21-ESQ-0136

**CLASS 1 MODIFICATIONS TO THE HANFORD FACILITY RESOURCE  
CONSERVATION AND RECOVERY ACT PERMIT, QUARTER ENDING DECEMBER 31,  
2020**

**Class 1 Modifications for Quarter Ending December 31, 2020**

A.29. 59A-TK-3 Filter Drain Sump Tank

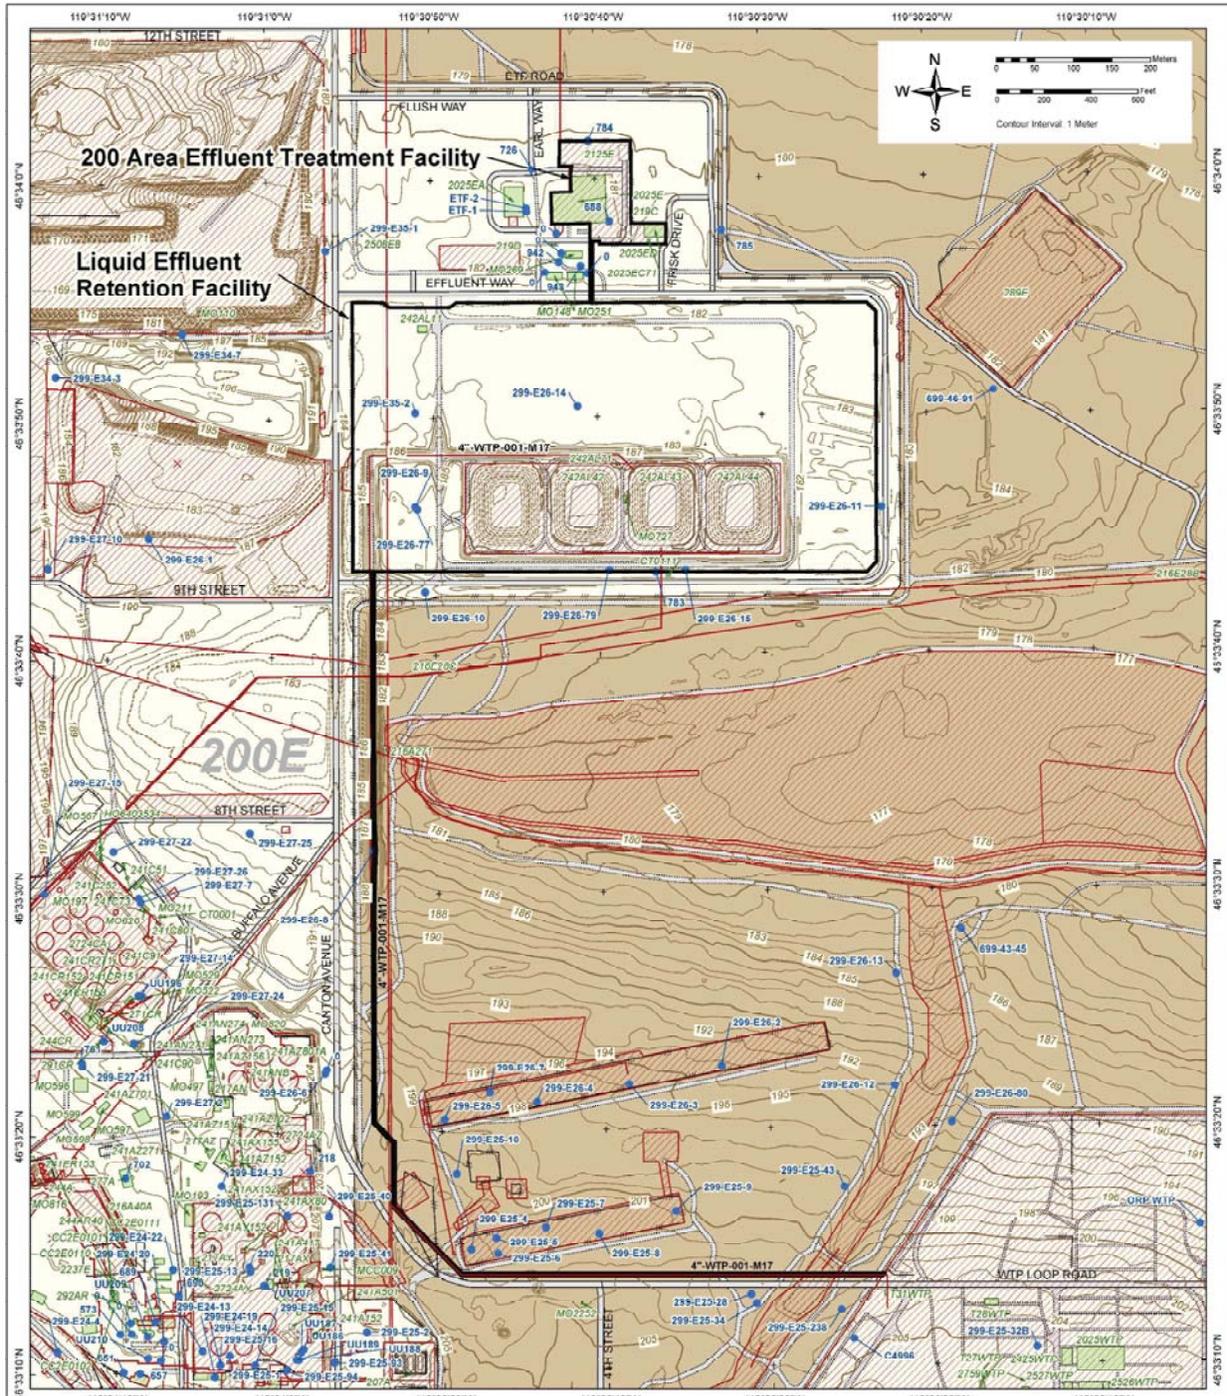
Revised Addendum A, "Part A Form," to include Figure A.29, photograph of Load-In Station Filter Drain Tank (59A-TK-3) to complete Permit Condition III.3.J.6.

Figure 6: Updated P&ID of Load-In Filter Assembly (H-2-81794, Sheet 2; ECN-714608, Sheet 4)

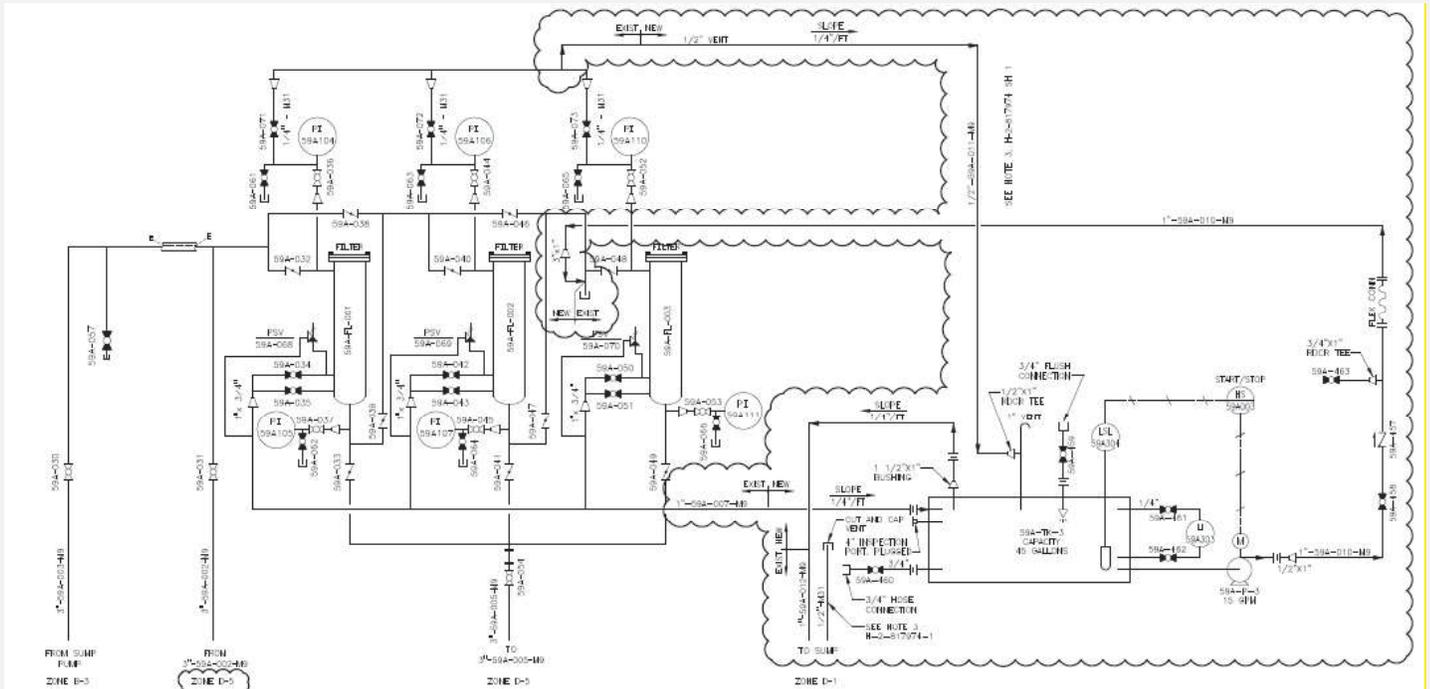
The overall details of the design change are documented in Modification Traveler MT-50409, *ETF Load-In Filter Drain Modification*; ECN-714608, *ETF Load-In Filter Drain P&ID ECN* and ECN-714609, *ETF Load-In Filter Drain Mechanical ECN*. Relevant codes and standards include ASME B31.3-2016, *Process Piping* and HNF-27957, *200 Area ETF, Load-In, and LERF Pipe Class Specification*.

Figure 9: Elevation View "A" of New Sump Tank 59A-TK-3 (Drawing H-9-6113, Sheet 1)

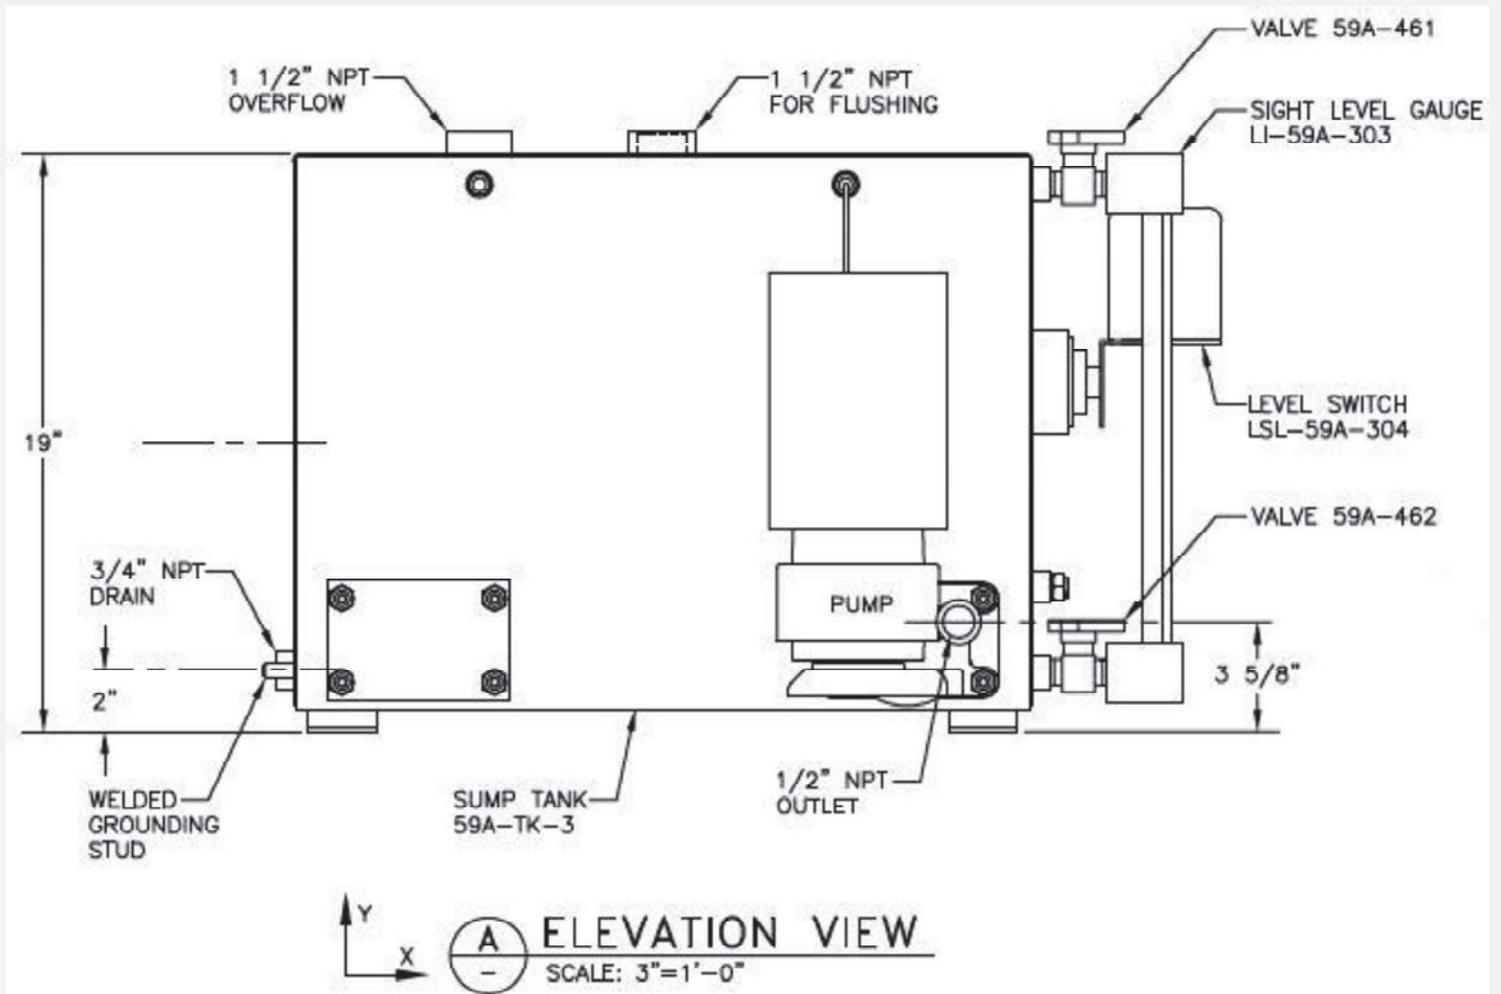
The three (3) load-in filters are not back-flushable and the elements require periodical replacement. In order to replace the filter elements, the filter housings are drained. Currently, the filter housings are drained into the existing secondary containment sump located outside of the truck load-in building. The filter housing contents are then pumped out of the sump using an existing pump.
